Project	IEEE 802.16 Broadband Wireless Access Working Group < http://ieee802.org/16 >		
Title	Clarifications for AAS Zone Allocations		
Date Submitted	2005-3-13		
Source(s)	Dave Pechner, Doug Dahlby, Todd Chauvin	ArrayComm Inc.	dpechner@arraycomm.com , dahlby@arraycomm.com , chauvin@arraycomm.com ,
Re:	IEEE P802_Cor1_D1		
Abstract	This contribution introduces clarifications for making allocations in an AAS zone in the OFDMA PHY		
Purpose	Adopt into P802.16d/D5 corrigenda		
Notice	This document has been prepared to assist IEEE 802.16. It is offered as a basis for discussion and is not binding on the contributing individual(s) or organization(s). The material in this document is subject to change in form and content after further study. The contributor(s) reserve(s) the right to add, amend or withdraw material contained herein.		
Release	The contributor grants a free, irrevocable license to the IEEE to incorporate material contained in this contribution, and any modifications thereof, in the creation of an IEEE Standards publication; to copyright in the IEEE's name any IEEE Standards publication even though it may include portions of this contribution; and at the IEEE's sole discreti

Figure 224a shows a legal UL AAS zone with an UIUC 12,13 allocation that is an integer number of slots in duration.

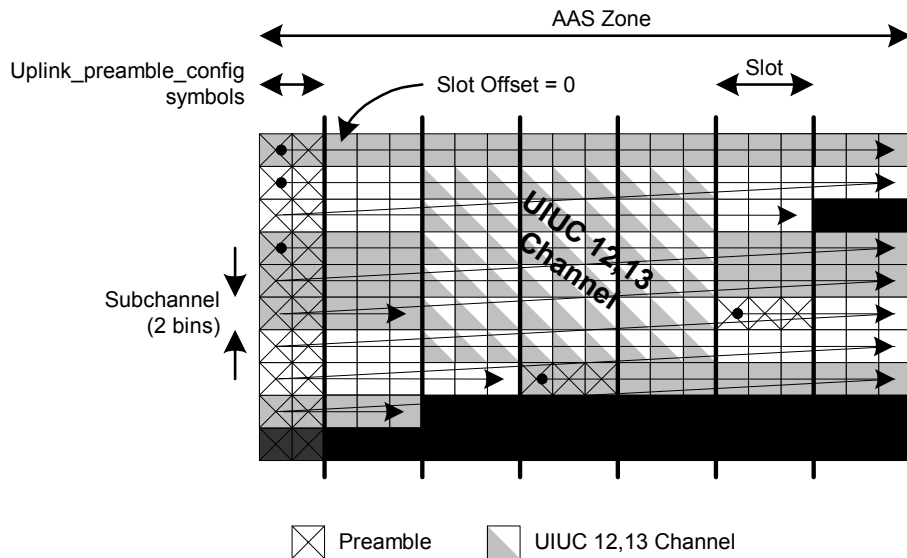
Require that UIUC 12,13 allocations in an UL AAS zone be an integer number of slots.

- When used in an AAS zone, a UIUC 12,13 region shall ~~either span all subchannels and consist of an arbitrary number of symbols, or be constrained to~~ be a multiple of 3 symbols in duration.

[replace Figure 224a with the following:]
